# UNITED STATES PATENT AND TRADEMARK OFFICE

APPLICATION NO.	FILING DATE	FIRST NAMED INVENTOR	ATTORNEY DOCKET NO.	CONFIRMATION NO.
10/509,553	05/17/2005	Manfred Ruehrig	1433.125.101/13.305	5911

**Office Action Summary**

*Figure 3*

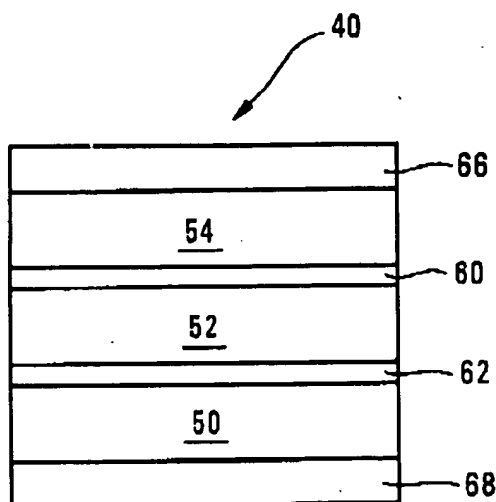
**Claim 10** is rejected under 35 U.S.C. 102(b) as anticipated by Anthony et al. (US 6,172,904).

**Regarding claim 10,** Anthony et al. discloses a method for fabricating a reference layer for MRAM memory cells, comprising:

system having a first layer (Fig. 3 layer #66) of a material having a first Curie temperature, wherein the first layer has a saturation field strength and can be permanently magnetized by an external magnetic field, and having a second layer (Fig. 3 layer #68) of a material having a second Curie temperature, which is significantly lower than the first Curie temperature, wherein the second layer can be magnetized by antiferromagnetic coupling with only the first layer (Anthony, Col. 3 line 62 – Col. 4 line 5);

a very thin intermediate coupling layer between the first and second layers (Fig. 3 layer #62);

forming an artificial antiferromagnet from the first, second and third layers by the steps of :

generating an external magnetic field having a field strength; (Anthony, Col. 4 lines 6 - 19)

cooling the layer system from a temperature above the first Curie temperature to below the first Curie temperature by action of the external magnetic field, the field strength of the external magnetic field being greater than the saturation field strength of the first layer, so that magnetization of the first layer is oriented by a second-order phase transition along the field direction of the external magnetic field; and (Anthony, Col. 4 lines 6 - 19)

subsequently cooling the layer system below the second Curie temperature, magnetization of the second layer being oriented antiparallel with respect to the magnetization of the first layer on account of antiferromagnetic coupling between the first and second layers. (Anthony, Col. 3 line 49 – Col. 4 line 19)
